CVL Job No. 8.13.03237.01

**AMENDMENT TO THE
MASTER UTILITY REPORT
MURPHY CREEK EAST DEVELOPMENT**

**MASTER UTILITY STUDY
FOR
MURPHY CREEK EAST DEVELOPMENT**

VILLAGES AT MURPHY CREEK
MASTER SANITARY SEWER PLAN

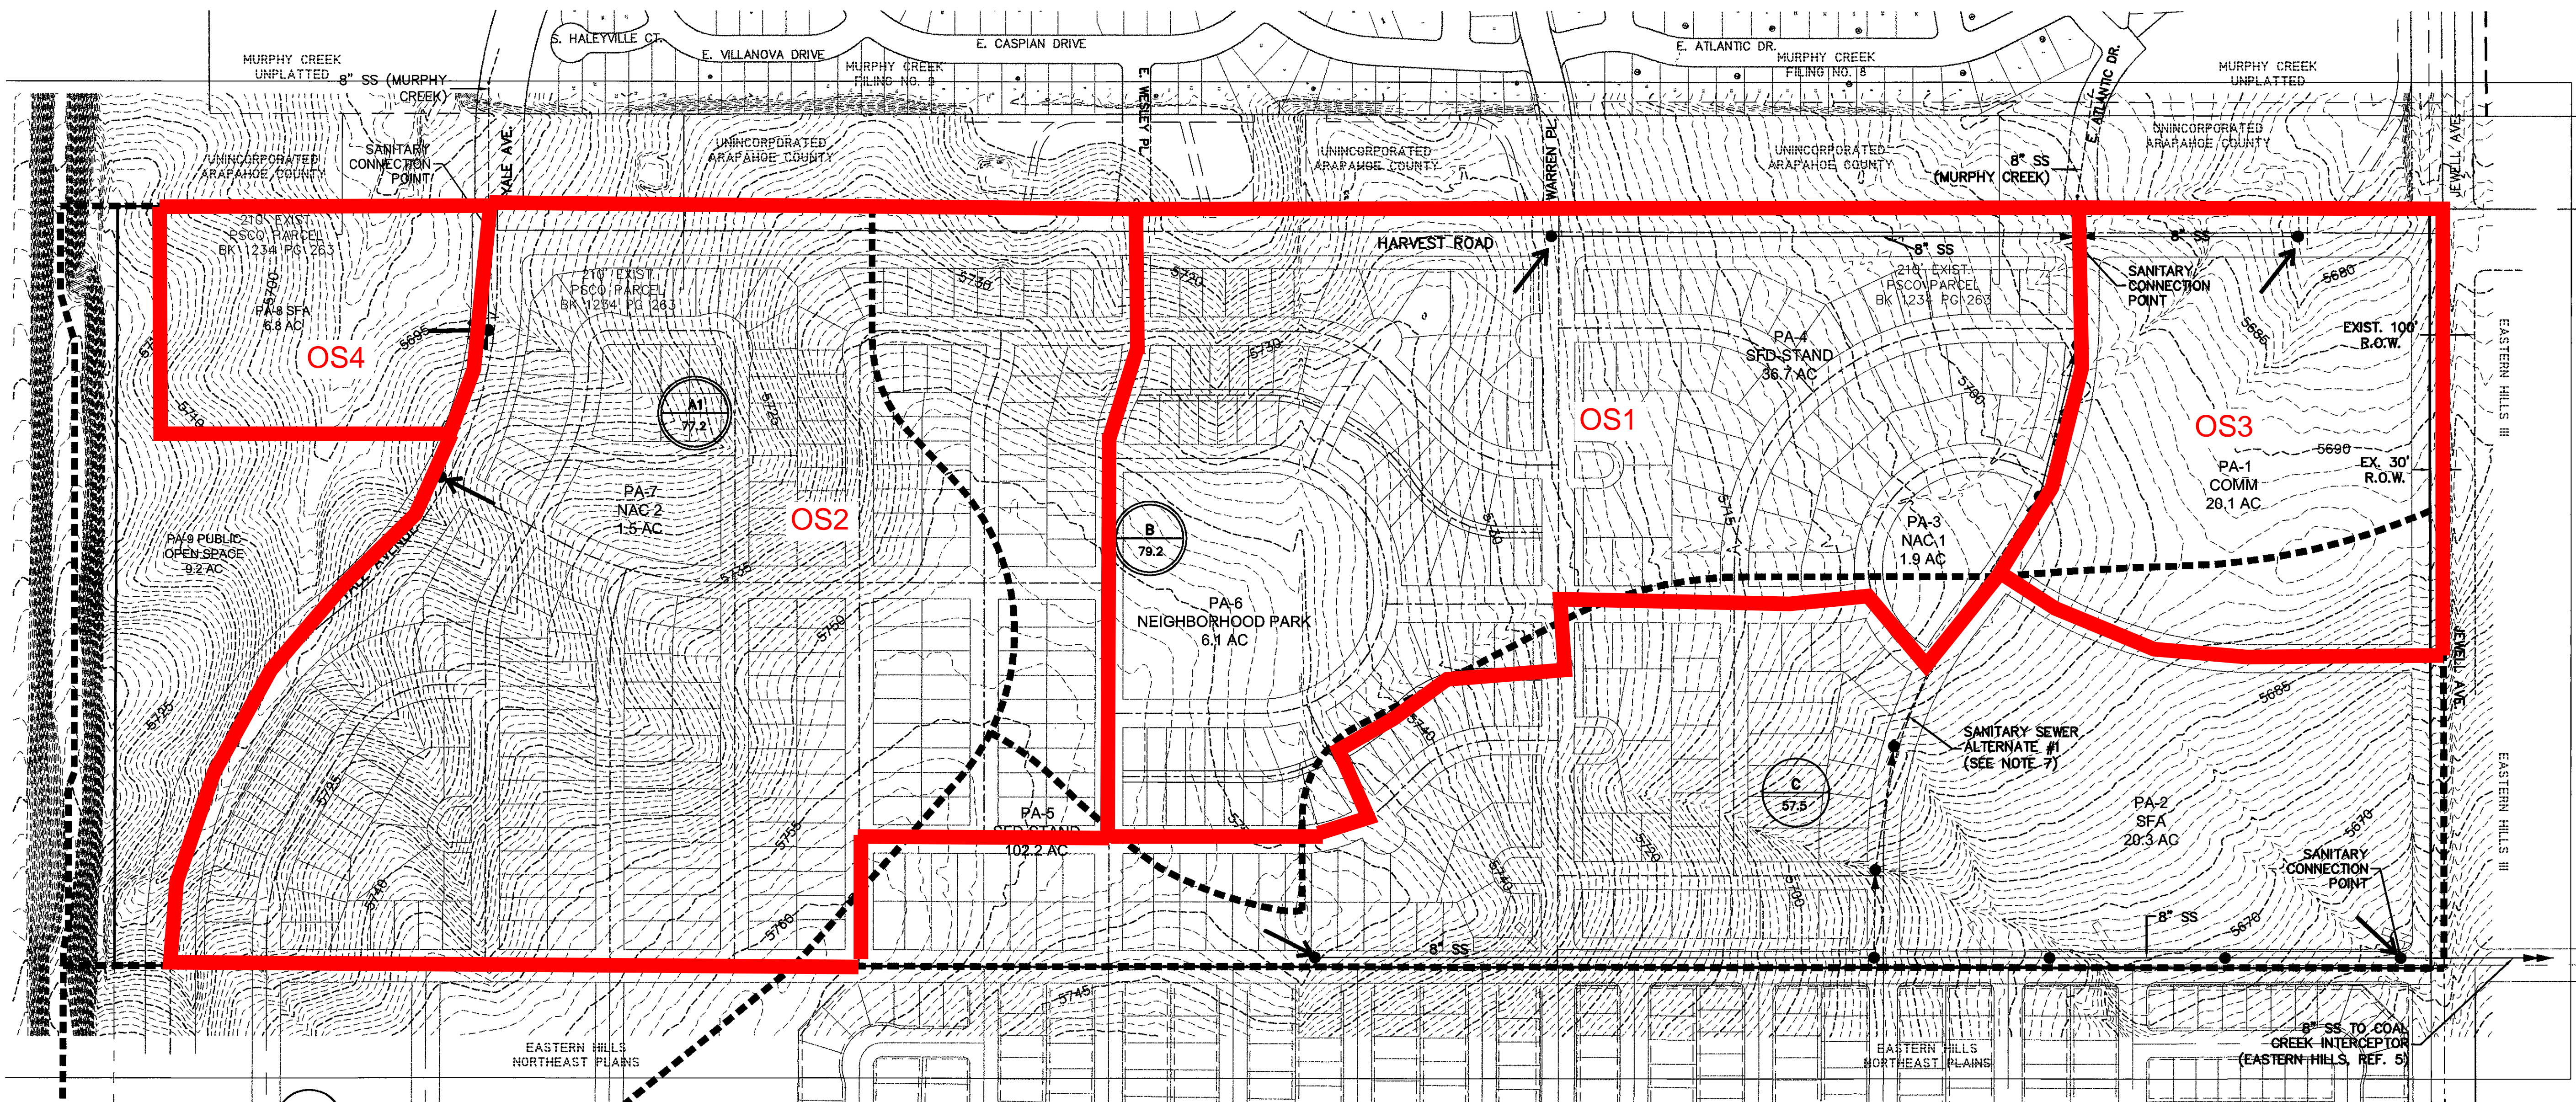
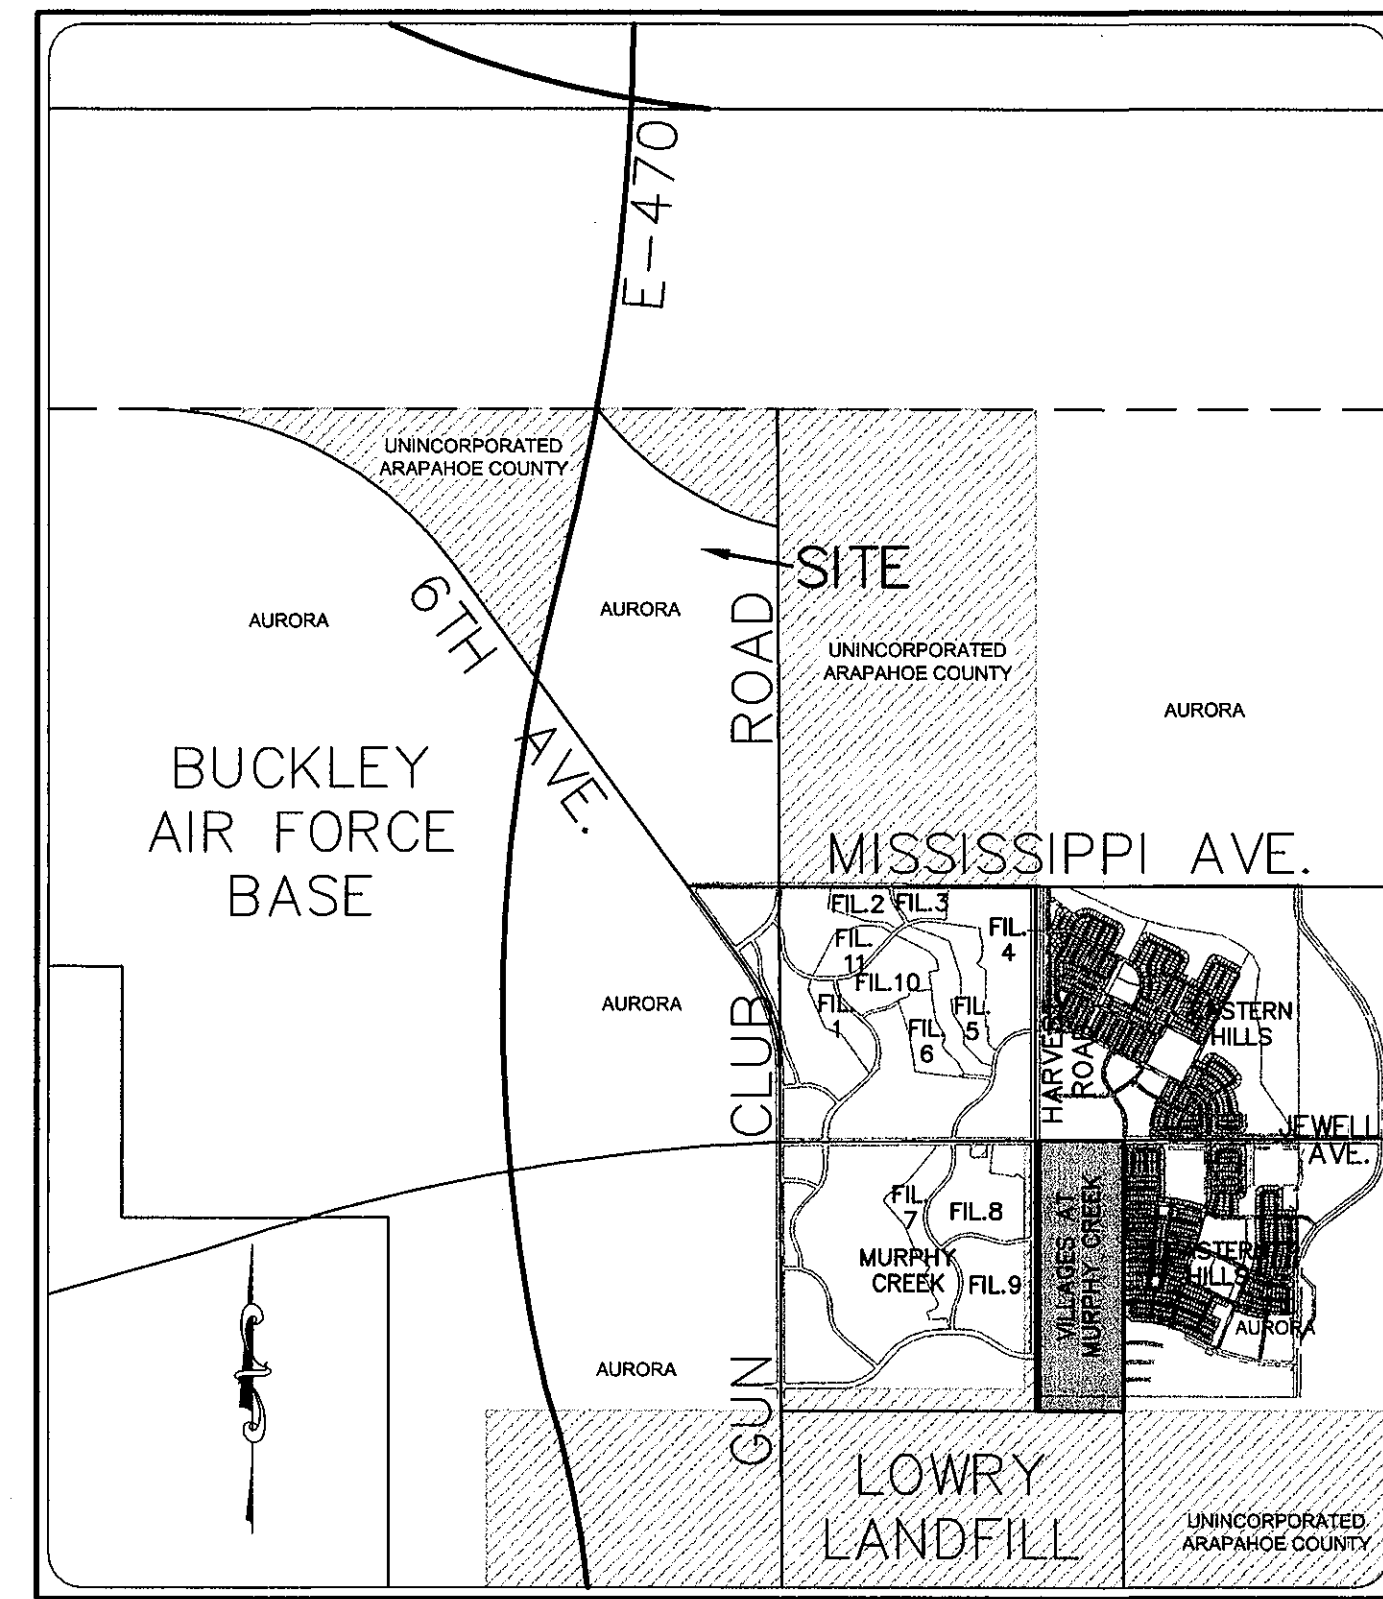
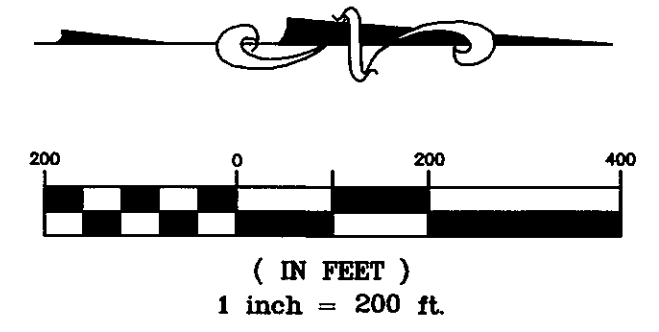
Per phone call on 12/17/19 with Sarah and Scott of CVL, please provide documentation from Villages at Murphy Creek ownership team(s) authorizing the modifications to basin boundaries and peak flow rates. Letter should also acknowledge that any future changes in density or use that results in an increase of flows will be that ownership team's responsibility to accommodate (i.e. up-sizing, paralleling, etc.). Please update all tables and reports as necessary, and include the documentation as an appendix to this report.

CVL has been in communication with the consulting team of Villages at Murphy Creek. CVL has incorporated their total number of units and flow rates that will need to flow through the Murphy Creek East development. Those updated flows are reflected in the sanitary sewer calculations.
